Access Compliance Report Public Rights-of-Way (Curb Ramps)

Main Street: TUBEROSE_ST Cross Street: BARBERRY_ST Location: NE

ADA ID: RPAT211029132223 Ramp Type: Type 4 - Parallel Initial Pass/Fail: Fail Overall Compliance: No Severity Score: 16

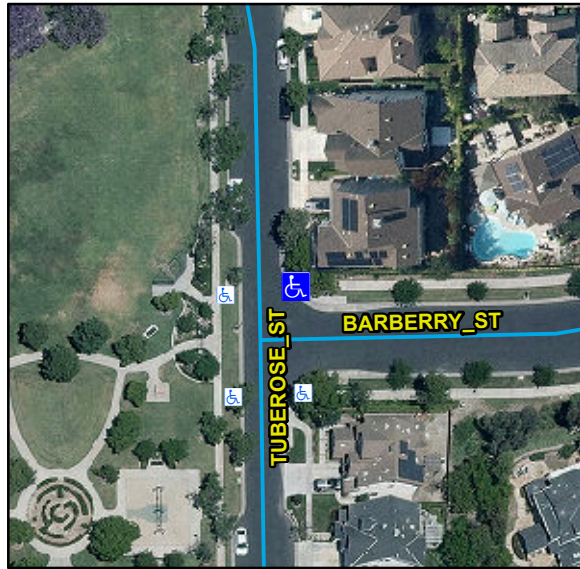
Compliance	Description	Data	Compliance	Description	Data
N/A	Ramp Length LT (in)	104	N/A	Ramp Length RT (in)	101
Yes	Ramp Width LT (in)	53	Yes	Ramp Width RT (in)	53
Yes	Ramp Run Slope LT (%)	1.3	No	Ramp Run Slope RT (%)	10.4
No	Ramp Cross Slope LT (%)	5	Yes	Ramp Cross Slope RT (%)	1.3
N/A	Landing Present	N/A	N/A	DWS Provided	N/A
N/A	Landing Length (in)	N/A	N/A	DWS Contrast	N/A
N/A	Landing Width (in)	N/A	N/A	DWS Length (in)	N/A
N/A	Landing Run Slope (%)	N/A	N/A	DWS Full Width	N/A
N/A	Landing Cross Slope (%)	N/A		DWS Offset Type	N/A
N/A	Landing Movement Obstructed?	N/A	N/A	DWS Offset Left (in)	N/A
	Landing Movement Type	N/A	N/A	DWS Offset Right (in)	N/A
N/A	Landing Shared	N/A			
N/A	Clear Space	Yes			
N/A	Clear Space To Crosswalk (in)	N/A			
N/A	Marked Crosswalk 1	No	N/A	Marked Crosswalk 2	No
	Crossing 1 Direction	W		Crossing 2 Direction	S
	Marked Crosswalk 1 Width (in)	N/A		Marked Crosswalk 2 Width (in)	N/A

Remove & Replace Curb Ramp With Two New Directional Ramps or Equivalent.

R204.3, R304.5.3, R304.3.2, STD 1115
